Colorado Department of Health

Review and Comment

Draft Phase I RFI/RI Workplan for OU 10
November, 1991

FIGURE A

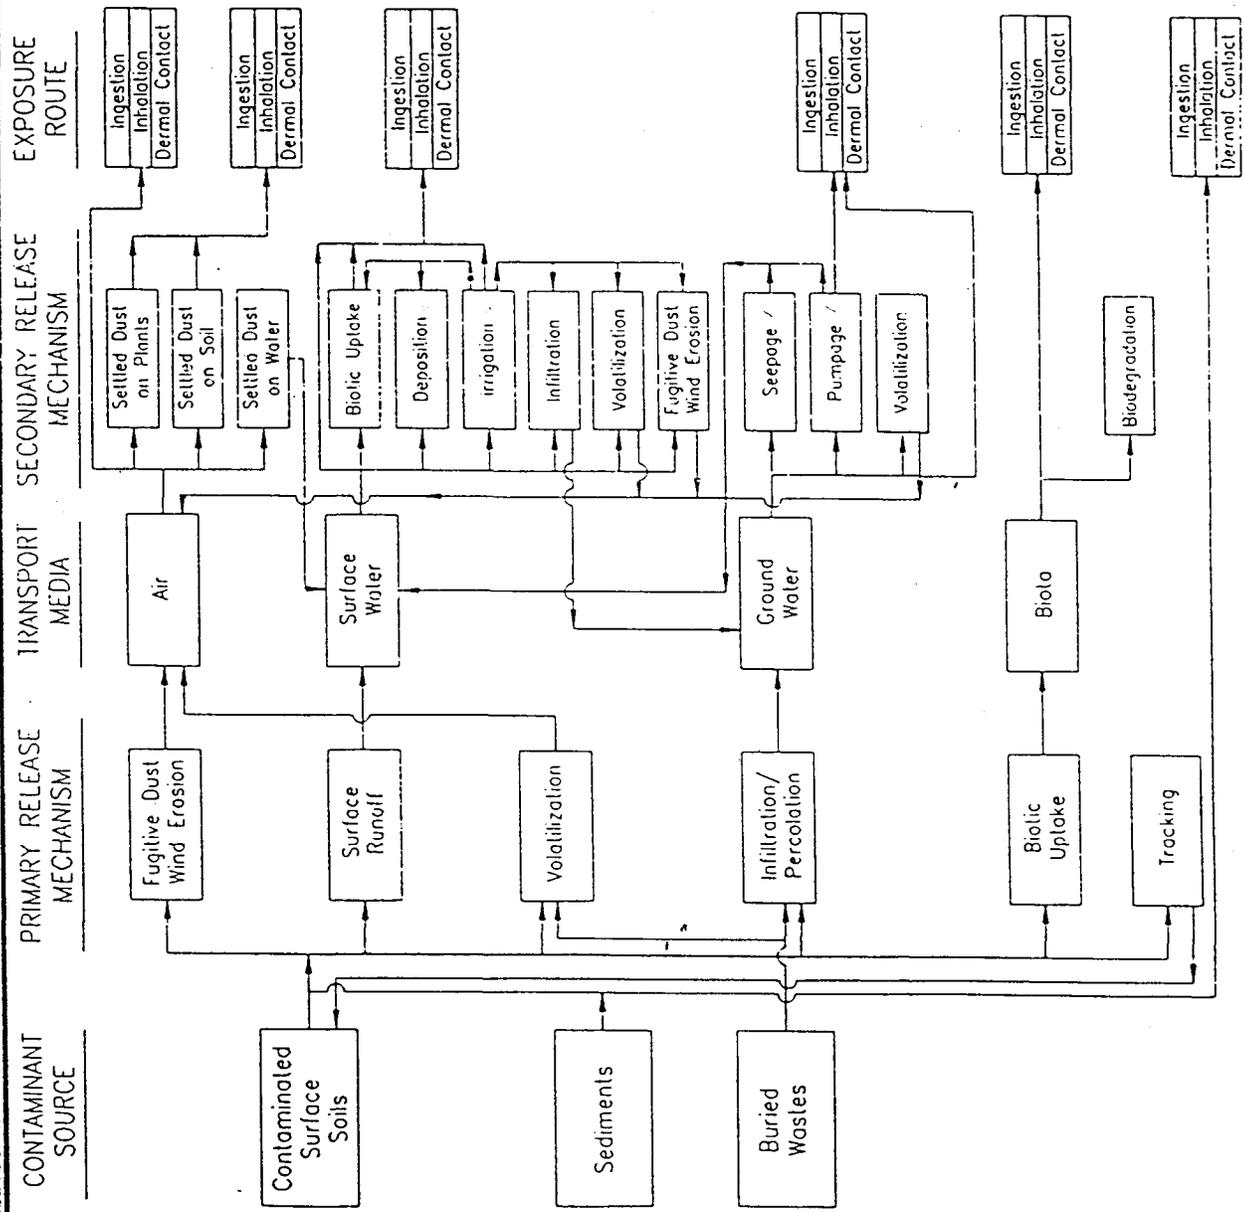
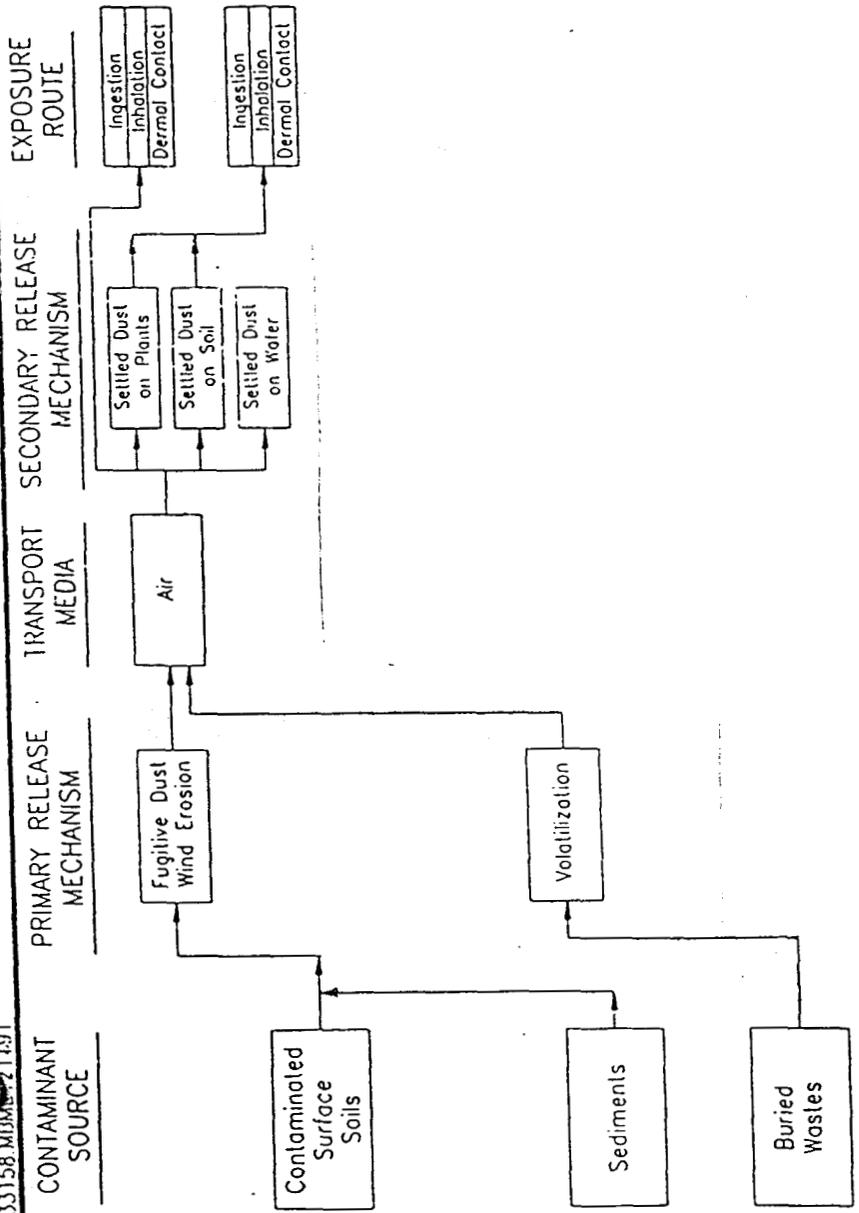
Section 2.2: General Comment 1: A pathway flowchart diagram was not included in this section and needs to be added (the Division suggests moving Figure 4.1-1 to Section 2.2). In addition, the pathways that will be addressed in Phase I versus Phase II need to be delineated. The Division has attached both a pathway flowchart diagram that has been used in other OUs and a modified version that represents the pathways we feel can be addressed in the Phase I investigation (please see attached Figures A and B). Previous staff level discussions concerning other OUs have concluded that Phase I RFI/RI Reports for each RCRA OU should include Baseline Risk Assessment calculations for each pathway that has been quantifiably investigated.

LITHOLOGIC AND CHEMICAL SAMPLING
FOR SOURCE CHARACTERIZATION
BOREHOLES IN ALLUVIUM

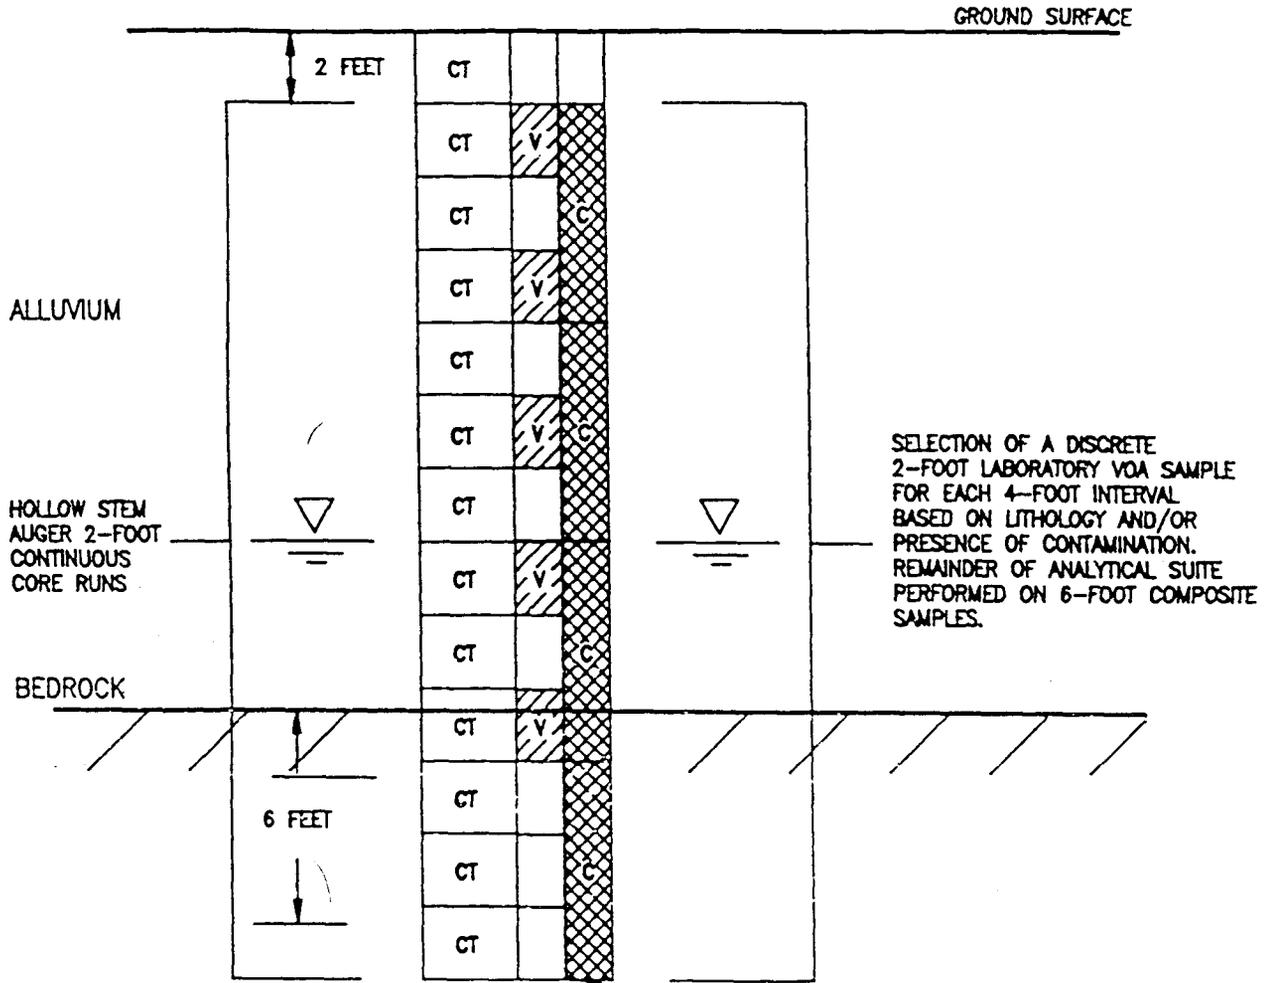
2) Previously approved soil sampling programs in other OUs have made an effort to distinguish between soil cores that will be collected to verify the soil gas survey (drilled to and sampled from a depth comparable to the depth that the soil gas samples were taken) and soil borings which help establish the nature and extent of any contamination (drilled to bedrock, sampled in various composite lengths depending on sample suite). The soil cores are randomly located on a percentage of the soil gas grid points. The number and location of soil borings is determined after the soil gas survey, radiation survey, and surficial soil data has been analyzed. The soil boring strategy is then submitted as a technical memorandum (TM 1) and usually includes borings in radiation hot-spots, plumes identified in the soil gas survey, and areas of other anomalous contamination. Please keep in mind that the Phase I investigation must completely establish the nature and extent of soil contamination. (Examples of borehole sampling programs from OU 2 are attached as Figures C and D.)

Section 7.4.4: The drilling procedure and purpose for the soil borings need to be consistent with investigations in other OUs. For instance, soil borings are always drilled 5 to 6 feet into bedrock. They are sampled differently above and below the water table and are sampled differently depending on their purpose (source characterization versus plume delineation). For the purposes of this Phase I investigation for OU 10, the source characterization method would seem the most appropriate. It is stated in this section that bedrock samples will be collected during drilling, but the IHSS specific sections of the FSP say that samples will be collected to within 1 foot of the ground water table. Please clarify these apparent contradictions within the text. (Again, refer to attached Figures C and D. Including this type of diagram in the workplan would be very helpful.)

FIGURE E

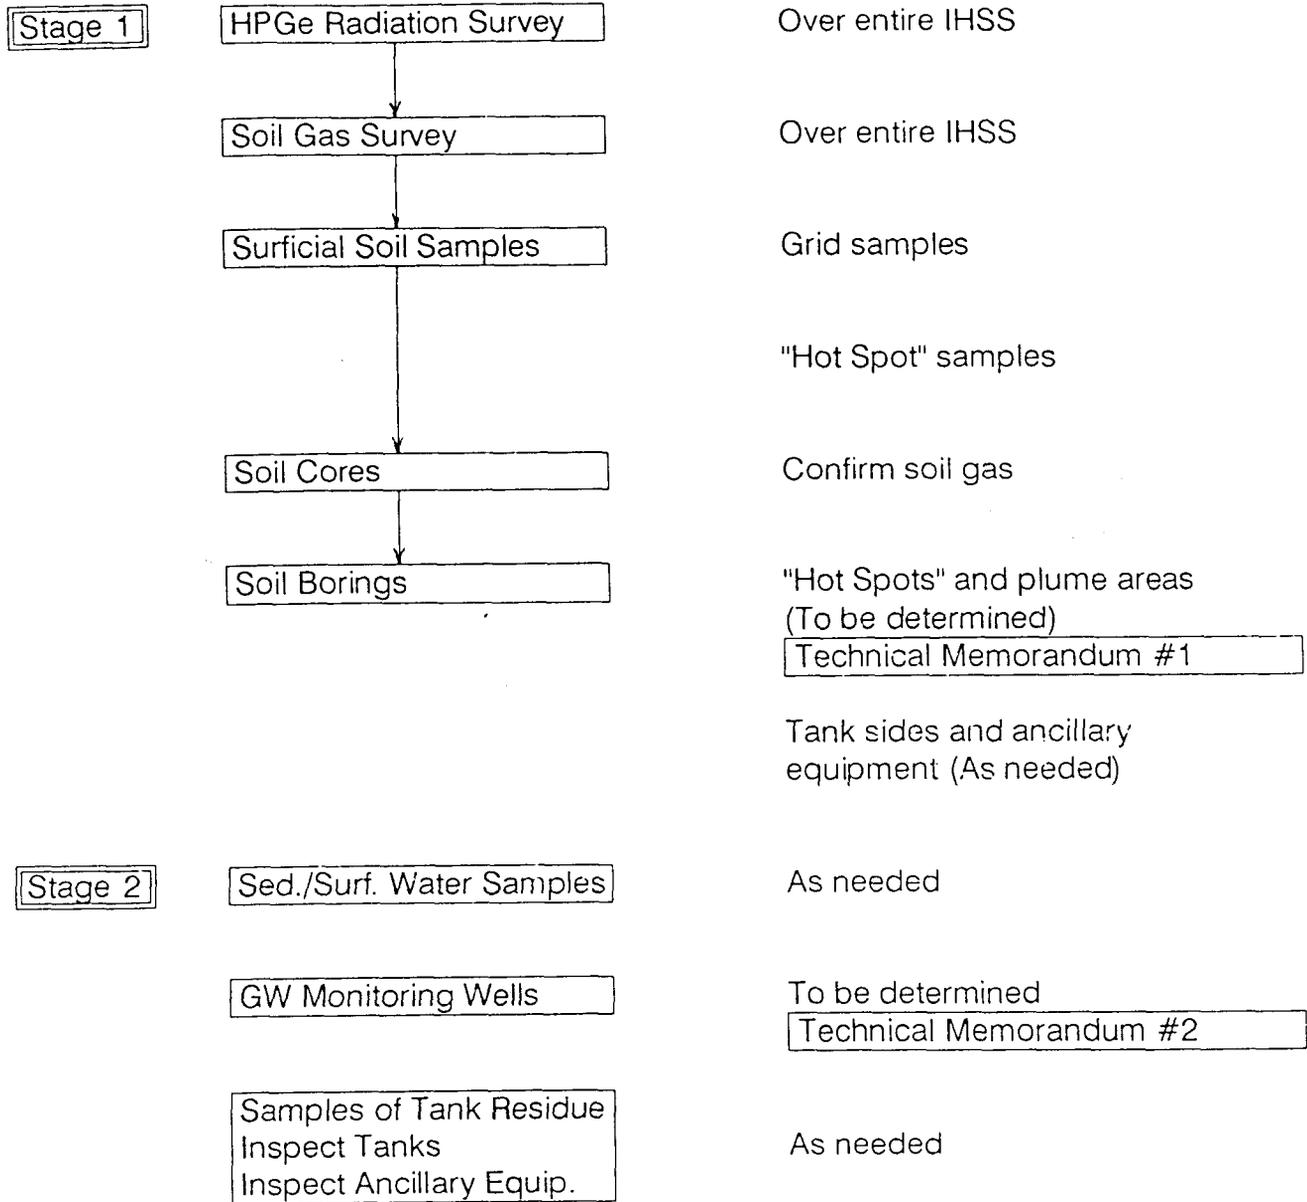
6) Most of the IHSSs in this OU present problems that can be investigated with a similar strategy. The Division has attached to these comments generic diagrams (Figures E and F) that represents an investigation methodology which we believe makes sense and is consistent with other OU field sampling programs. These figures illustrate how we visualize the implementation of the preceding general comments. They create a staged implementation that utilizes the Observational Approach.
